### APPEAL SUMMARY

**Appeal ID:** 19041

**Project Address:** 631 SE Taylor St

**Building/Business Name:** The Rose Apartments

8  
GA4  
NORTHEAST EXIT STAIR - THIRD STORY  
1/4" = 1'-0"

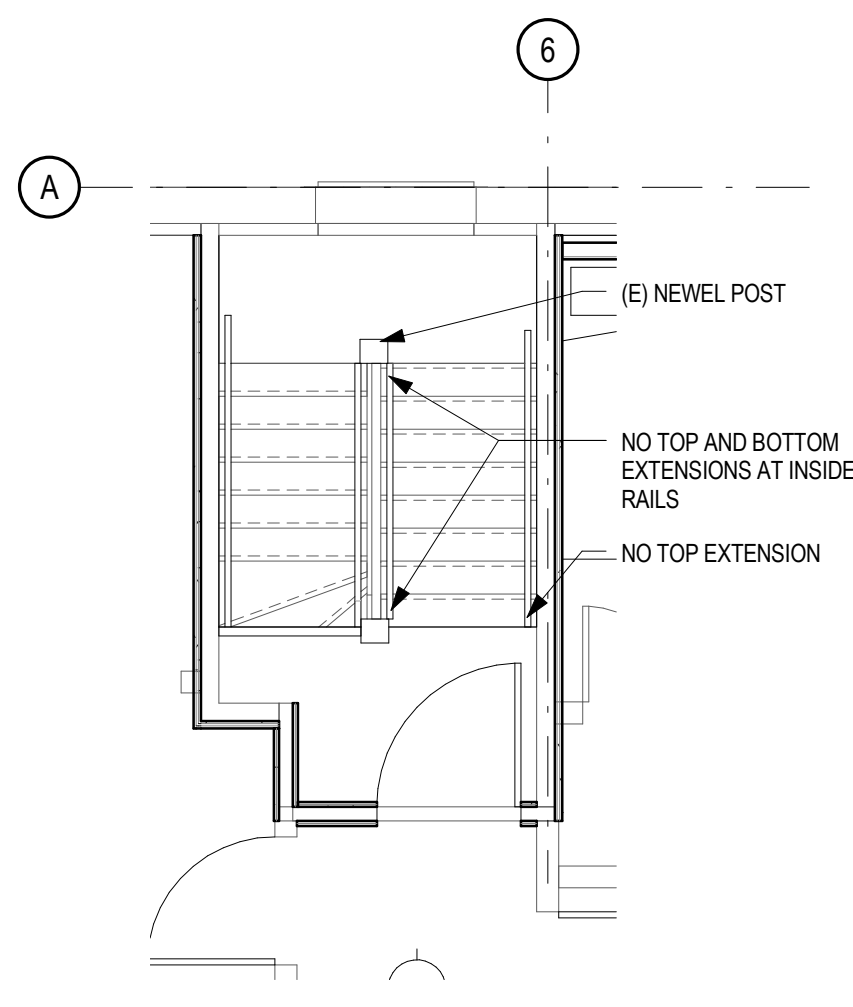
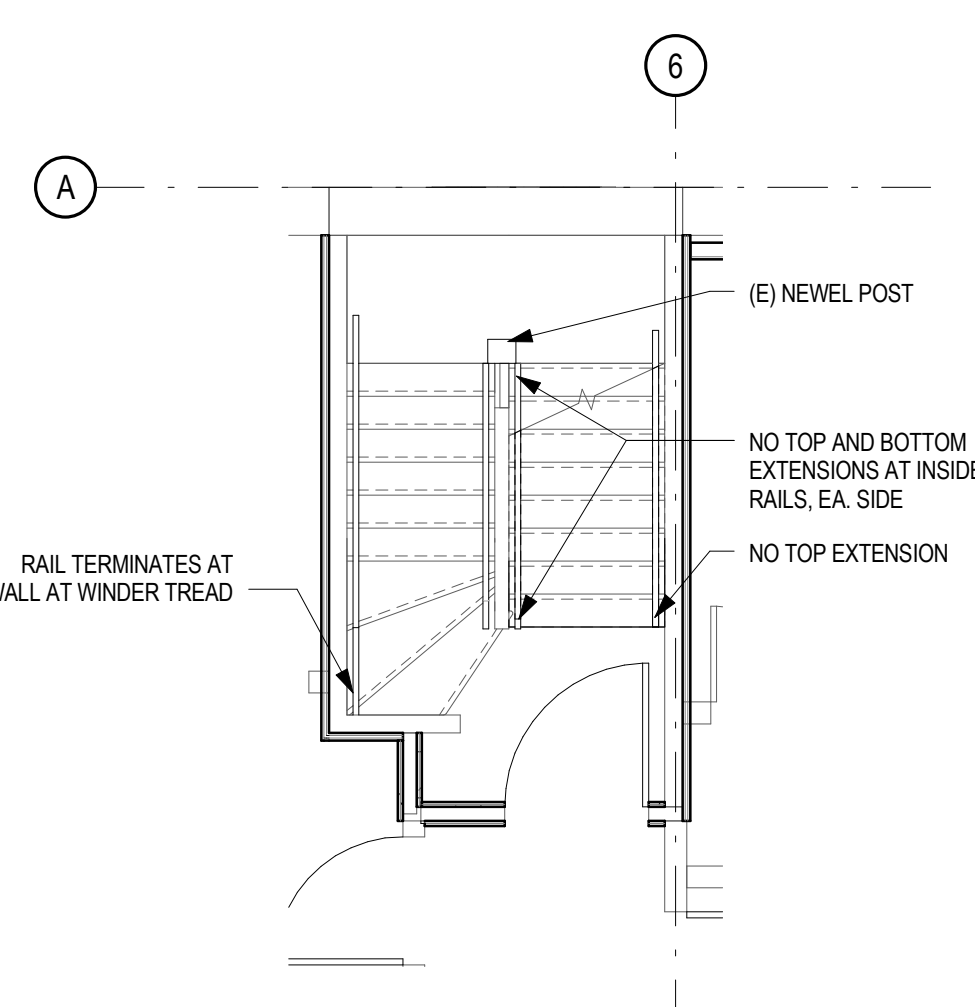
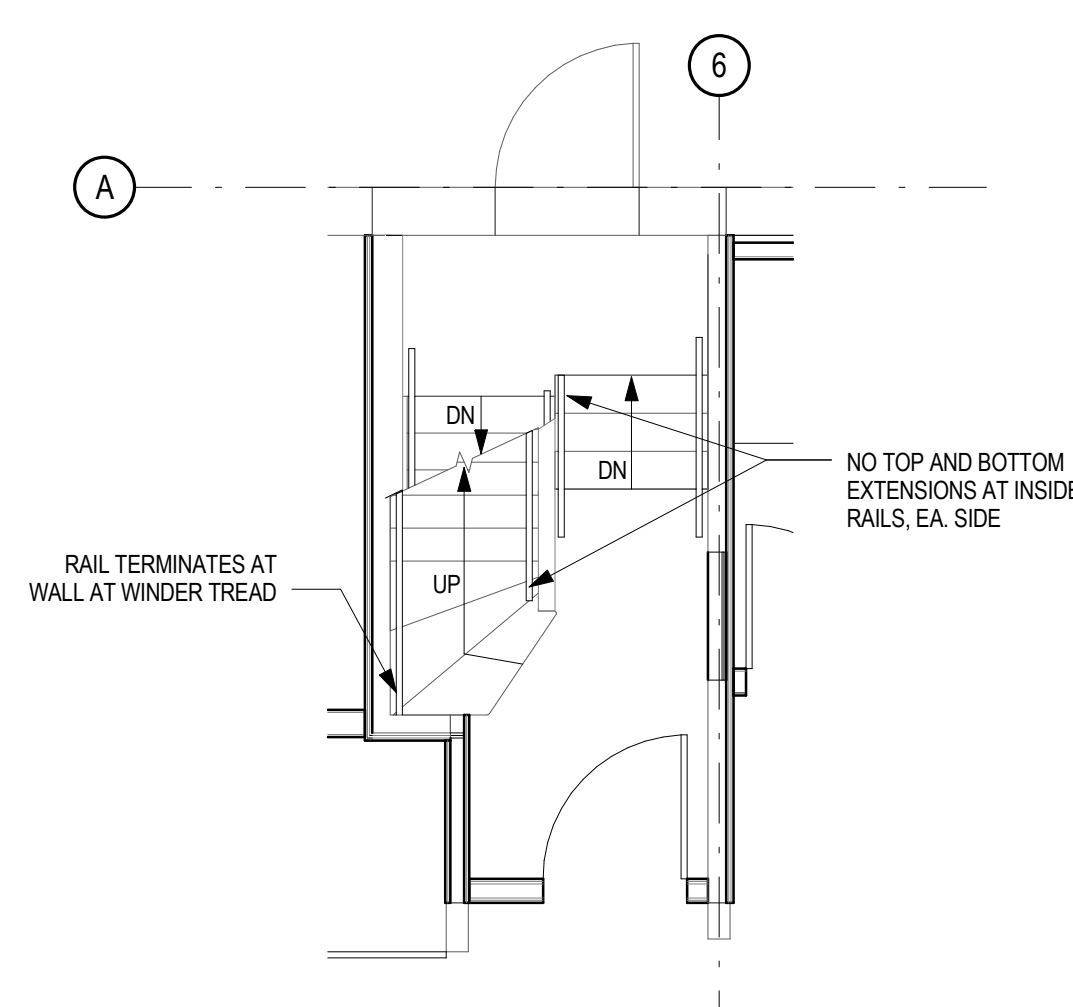
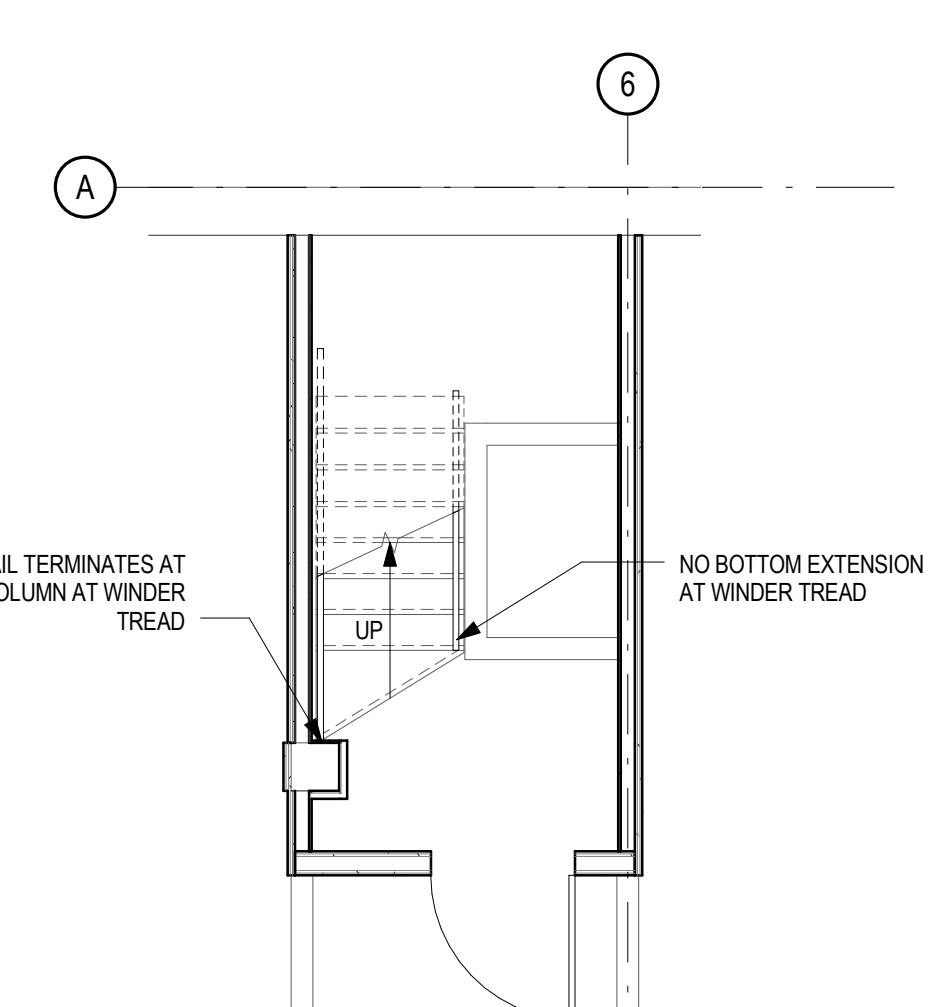
<b>Code Section</b>	1009.7.3 Winder Treads
<b>Requires</b>	Winder treads are not permitted in means of egress stairways except within a dwelling unit.
<b>Proposed Design</b>	<p>ORIGINAL APPEAL TEXT: The existing winder treads in northeast and northwest stairs will remain. These have been approved by previous appeals dated 8/8/74 and 1/27/88. The exit stair enclosures will be repaired to achieve the required 1- and 2-hour construction. New rated doors will be provided. New lighting to meet the requirements of Section 1006 will also be provided within the stair enclosures. See Details 2, 3, 5 and 8/GA4.</p> <p>RECONSIDERATION TEXT: The existing winder treads in northeast and northwest stairs will remain. These have been approved by previous appeals dated 8/8/74 and 1/27/88. The exit stair enclosures will be repaired to achieve the required 1- and 2-hour construction. New rated doors into the enclosures and to the Egress Court will be provided. New lighting to meet the requirements of Section 1006 will be provided within the stair enclosures. A sufficient landing inside the basement enclosure door will be provided in Stair S001, where there is no landing currently. An existing noncompliant opening into Stair S101 will be removed and filled in with 2-hour fire barrier construction. Handrails complying with height requirements of 1012.2 will be provided on either side where there are only handrails on one side currently (refer also to Appeal Item #4 – Handrail Extensions).</p> <p>See Details 2, 3, 5 and 8/GA4, and Details 1, 2, 3 and 5/GA5.</p>

<b>Code Section</b>	1012.6 Handrail Extensions
<b>Requires</b>	Where handrails are not continuous between flights, the handrails shall extend horizontally at least 12 inches beyond the top riser and continue to slope for the depth of one tread beyond the bottom riser.
<b>Proposed Design</b>	<p>ORIGINAL APPEAL TEXT: Within the existing northeast and northwest exit stairs, compliant top and bottom rail extensions will be provided where the plan configuration allows. Where there is not room for extensions due to existing conditions and space constraints, extensions will not be provided. See Details 2, 3, 5 and 8/GA4 for more detailed information.</p> <p>RECONSIDERATION TEXT: Within the existing northeast and northwest exit stairs, compliant top and bottom rail extensions will be provided where the plan configuration allows. Handrails will wrap the wall at winder tread locations. Where there is not room for extensions due to existing conditions and space constraints, extensions will be provided to the maximum length possible. See Details 2, 3, 5 and 8/GA4 and 1, 2, 3, 4 and 5/GA5 for more detailed information.</p>

**2. Winder treads in 2 egress stairs: Granted as proposed.**

**3. Omission of handrail extensions in 2 egress stairs: Granted as proposed.**
